# Groundwater Transfer Review Summary Form

Transfer/PA # T- 14423

Application: T-14423

Applicant Name: Richard Lynch

**Groundwater Levels (October-November)**

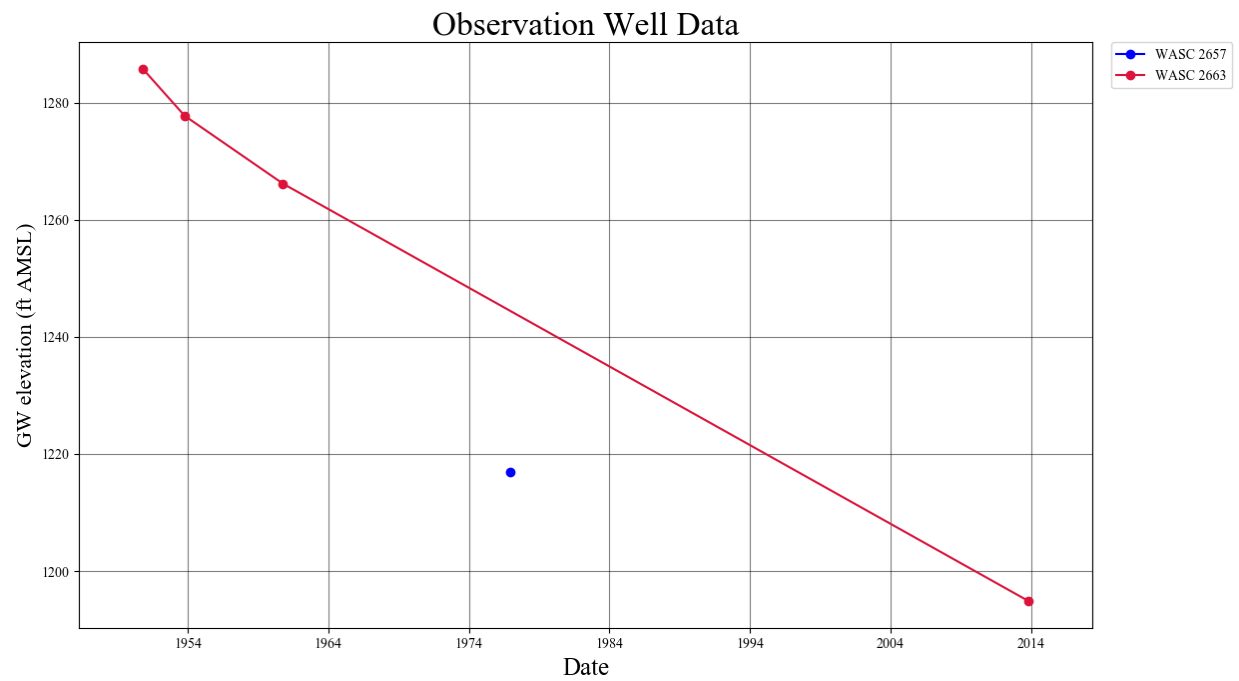
The only water level data for the proposed POA (WASC 2657) is 1217 feet amsl, measured by the driller on 11/27/1976 shortly after drilling and construction was completed. There is a large water level data gap between 1962 and 2012 for the existing authorized POA (WASC 2663), but the measurement at the proposed POA falls between the measured October water levels for the existing authorized POA (1266 feet amsl, 10/10/1960; 1195 feet amsl, 10/23/2013).

**Theis Interference Analysis**

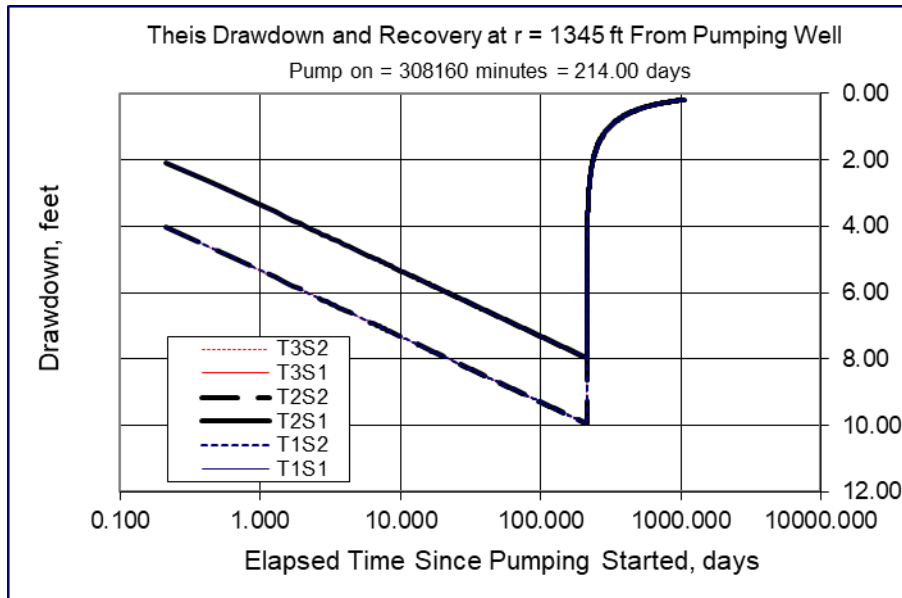
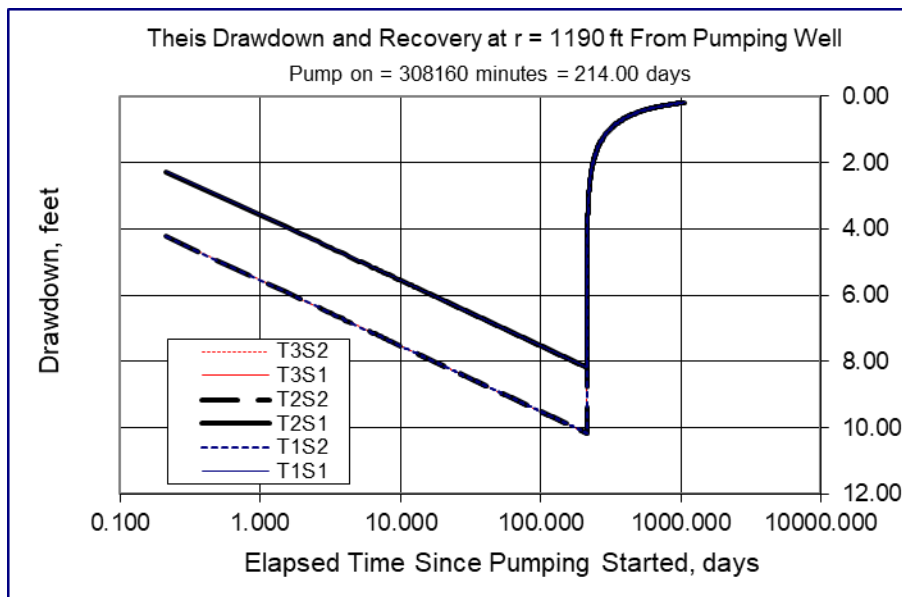
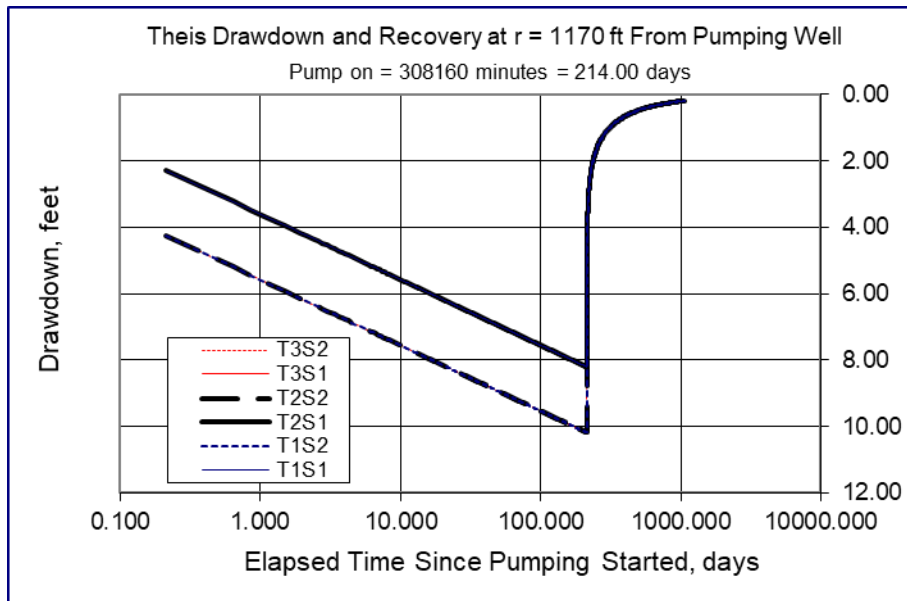
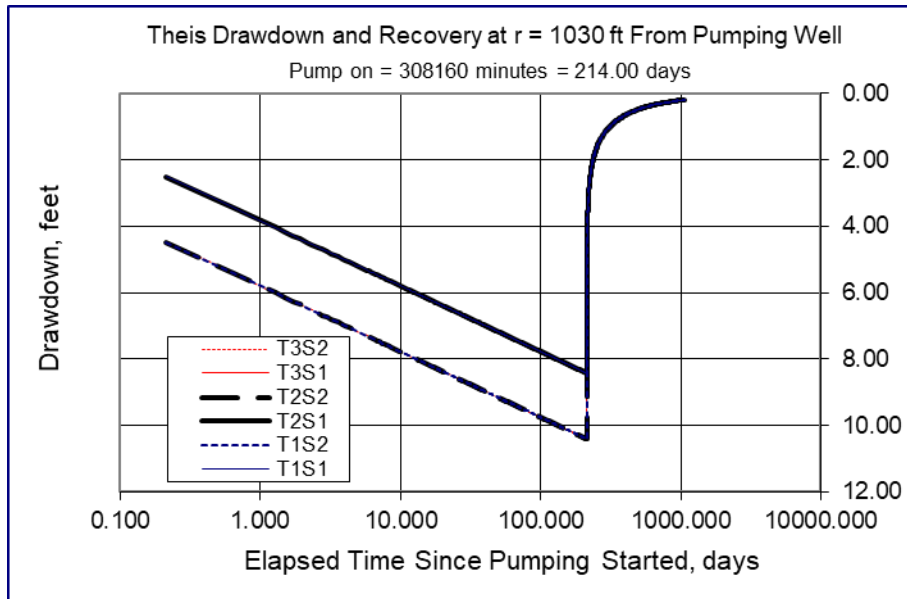
5. a) Will this proposed change, at its maximum allowed rate of use, likely result in an increase in interference with **another ground water right**?  
☒ Yes ☐ No Comments: The groundwater rights nearest to the existing authorized POA and proposed POA are associated with WASC 50498, WASC 2661, and WASC 2662. WASC 50498 is likely sealed to a deeper water bearing zone than WASC 2663 (Well 1) and WASC 2657 (Well 2) and will not experience interference due to pumping at either well. The proposed POA is ~150 feet closer to both WASC 2661 and WASC 2662. Pumping at the maximum allowable rate of 0.50 cfs for 214 days (irrigation period) at the proposed POA would result in an increased drawdown of <0.5 feet.

- b) If yes, would this proposed change, at its maximum allowed rate of use, likely result in another groundwater right not receiving the water to which it is legally entitled?  
☐ Yes ☒ No If yes, explain: The resulting increase in interference at WASC 2661 and WASC 2662 when pumping at the maximum allowable rate at the proposed well is negligible.
